Ministry of Livestock, Fisheries and Rural Development
Department of Rural Development
National Community Driven Development Project
IDA Grant: H813-MM

Final Report

Technical Audit

A review of technical quality of the Sub-Projects in
the first cycle of implementation

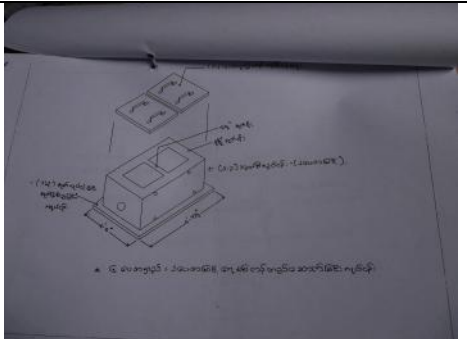
The SP was for the widening an existing village road by 2 feet (60 cm). The work was completed 11 days, with 90 villagers working for 5 days and 40 villagers working for 6 days. The construction did not include any culverts although the VPSC reported that three culverts are needed. Side drains were constructed but the road has no camber so water flows along the road as seen in the photographs above.

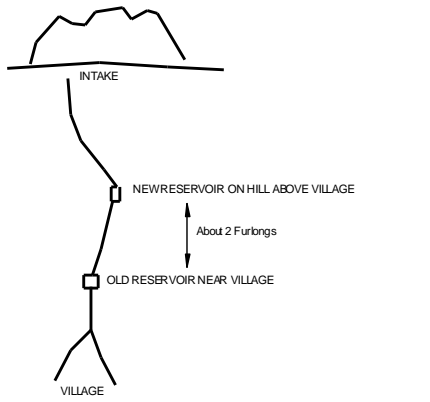
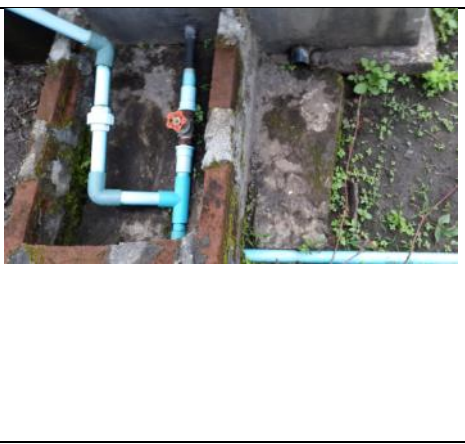
The SP constructed a one room extension to a small village primary school. The quality of the works was good, with improvements recommended in painting and fixing of the gutter. No furniture was provided by the SP.

<p>Water intake. The VPSC plan to construct a fence to prevent animals from falling into the reservoir.</p>	<p>Erosion under the tank from overtopping of the reservoir.</p>

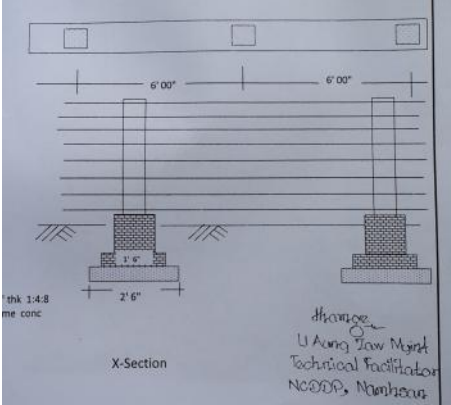
There is an erosion problem under the reservoir as shown in the photographs above. When the water tap is closed at the turbine, the reservoir fills up very quickly and can overtop. The hill has collapsed under one corner of the tank. This needs to be repaired urgently, and a larger spillway constructed so the water is released safely during times of heavy flow. The erosion problem with the reservoir is a design mistake that needs to be corrected, rather than an environmental issue. The diversion canal has a gate that can be opened so no water reaches the reservoir.

<p>Front view of school</p>	<p>Additional work is required to cut soil at rear of building where the new room was added.</p>

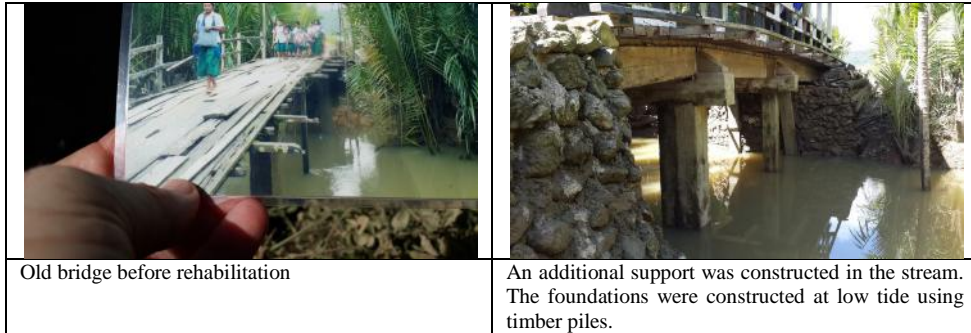
Additional earthwork and drainage is required behind the school to move the slope a safe distance from the building and to prevent erosion. The entrance to the school is up a steep hill with steps cut into the soil. These steps should be reinforced with stone or timber and the sides planted with grass to make the entrance safe in the rainy season.

<p>Village meeting.</p>	<p>The drawing of the intake, showing the dam and outlet pipe, has insufficient information for construction. No filter is shown.</p>

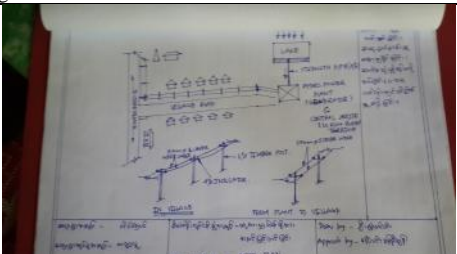
The new water tank, intake and supply pipe was constructed with household connections added by the villagers. The water supply is connected directly to the village so the water tank is used for storing excess water at night to be used in the morning when demand is highest. If the tank was designed properly this arrangement should not be necessary. The system is functioning as it, so there should be no issue. The drawings used for the construction were not really acceptable, as shown in the photograph above.
